SEVERANCE OVERLAY ZONE: COMMENTS, QUESTIONS, AND CONCERNS

COMMENTS AND RESPONSES AS OF DECEMBER 4, 2025

Severance C-4 Design Comparison

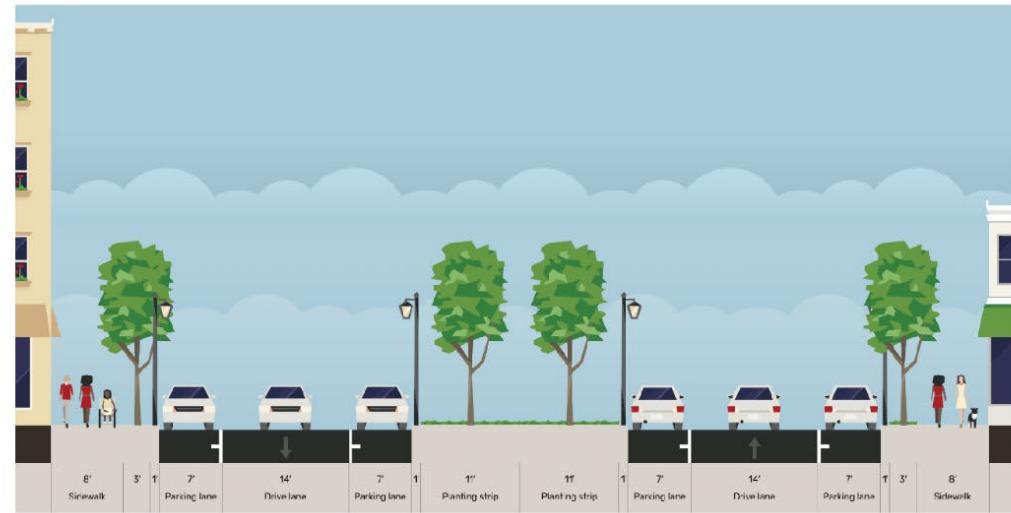
C-4, "Phase 1 Main Boulevard"

Issues: Same overparking, lane width, small planting zone, bike lane, and PF issues as **B-1**. See *attachment for visualization.* TMC requests changes.
